MEMORANDUM

To: The Design Advisory Board
From: Mary O'Neil, AICP, Principal Planner
RE: ZP17-1341CA; 3-11 George Street
Date: July 11, 2017

Request: Renovation of existing mixed use building, including exterior repair, replacement of asphalt siding on rear ell with clapboard, remove chimneys on rear ell, re-open boarded up openings, painting brick exterior, window replacement, roof replacement, new entry steps, railings and exterior doors.

STANNARD HOUSE RENOVATIONS

sheet no.
A4.1

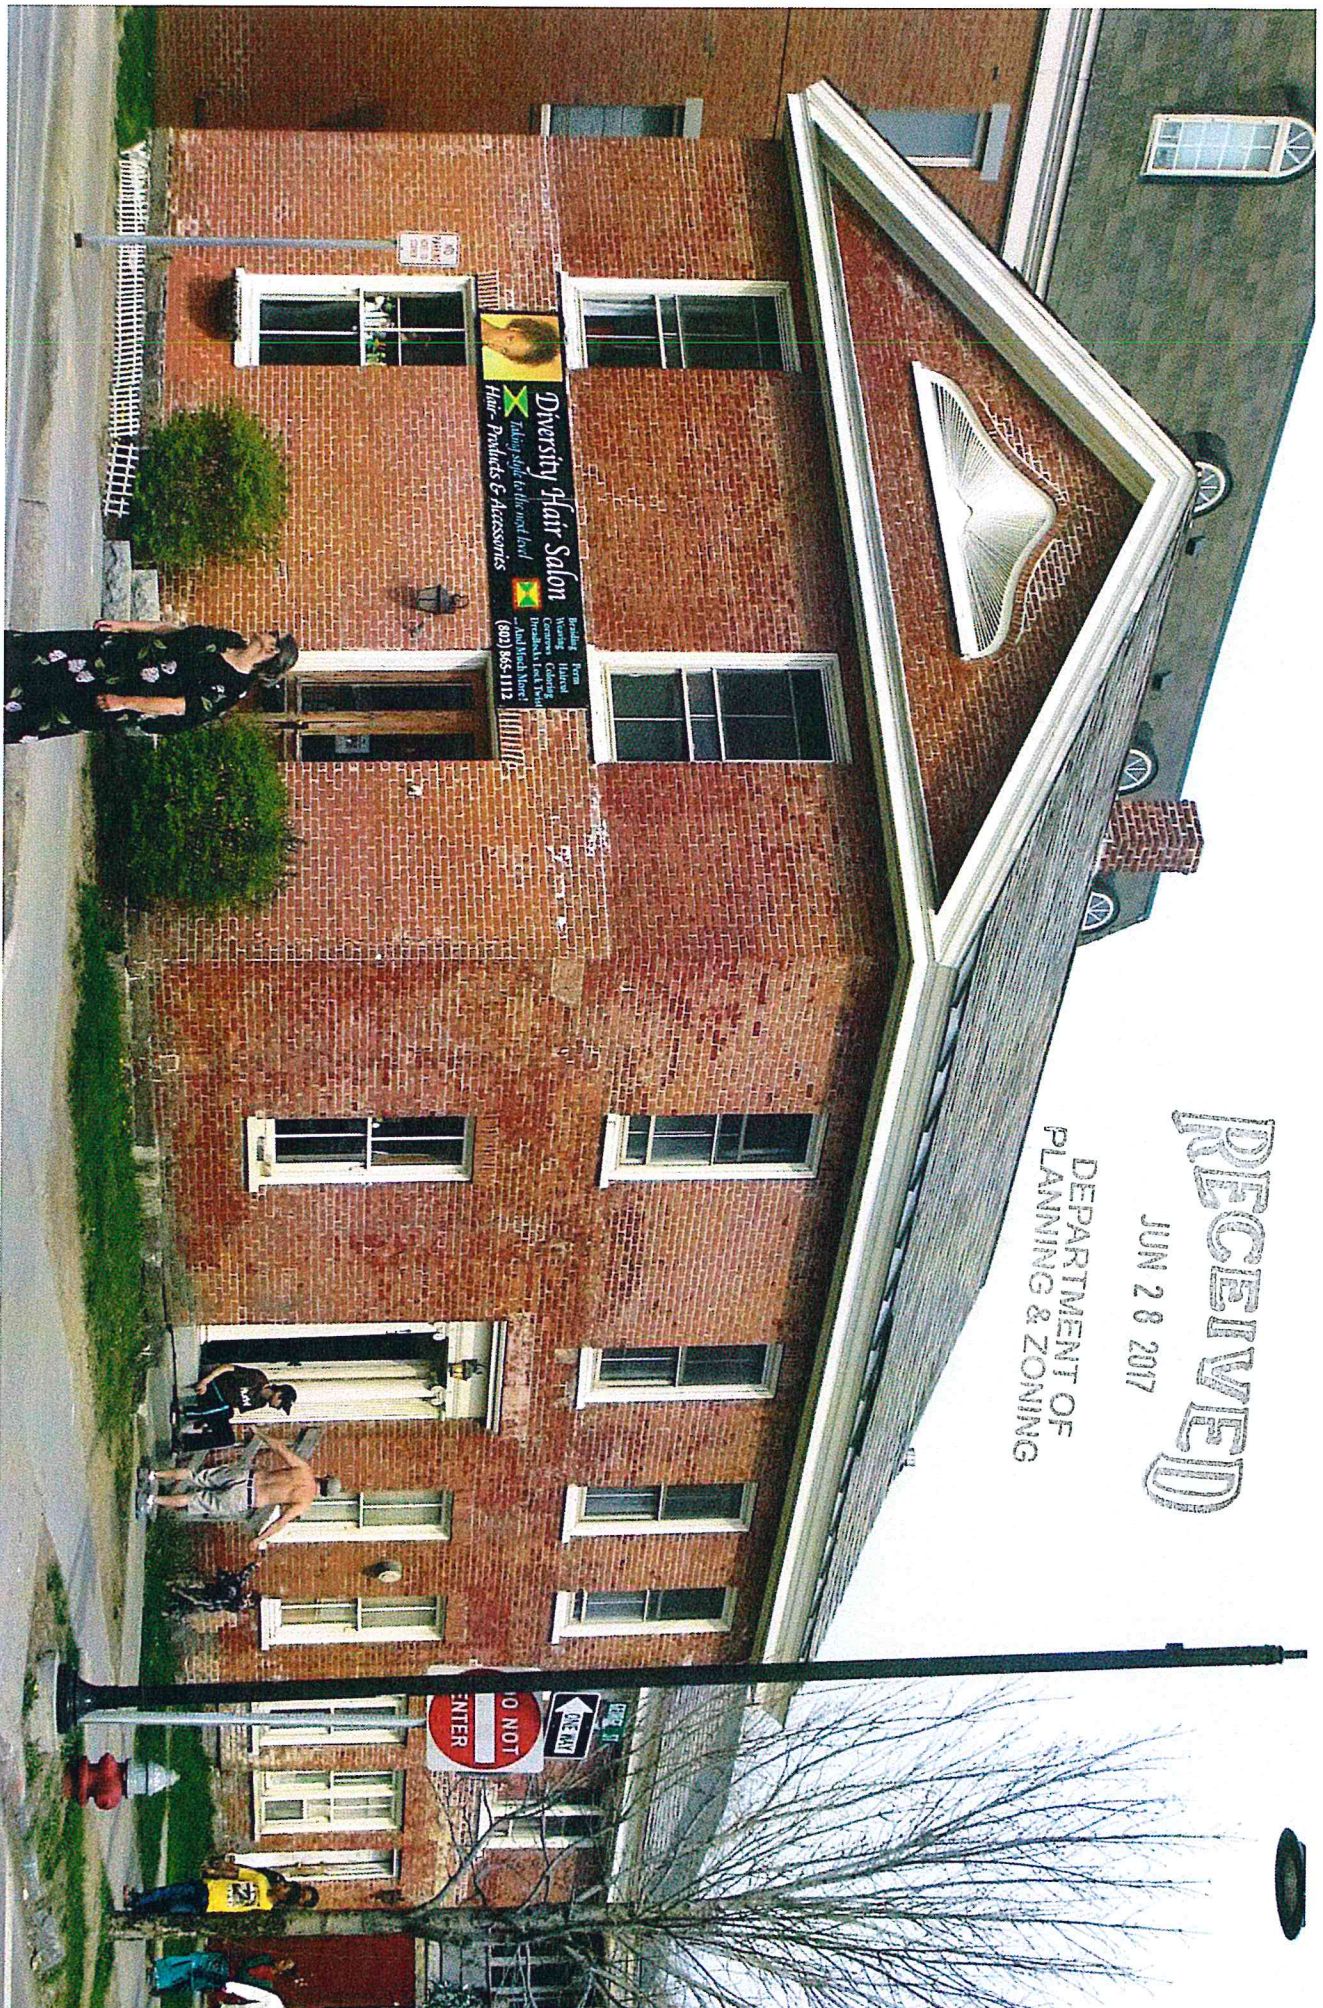
Generally, the work proposed is of a repair and maintenance character. The proposed effort to paint the building has no foundation (which cannot be supported simply by the presence of painted masonry buildings in the area), and is advised against.

Without strong evidence and a documented history of having a painted exterior, painting the brick now is not recommended.

See detail sheet A4.1 for specific treatment plan.

Painted brick is proposed to address incorrect mortar repair and masonry damage. This effort is not substantiated with written opinion from qualified preservation contractors or consultants.

Of particular concern is the proposal to paint the brick exterior. The building has remained unpainted for the documented history of the building. A previous assessment (done during the Victoria Place review) acknowledged traces of paint, but there remains no photo documentation or description of the property with a painted exterior. Uneven surface coloration and differences in mortar repair can explain the inconsistent surface pattern. This is not something to “correct” with paint, but can be embraced as part of the evolution of the building. These differences in fact lend credibility to the storied past of the building.
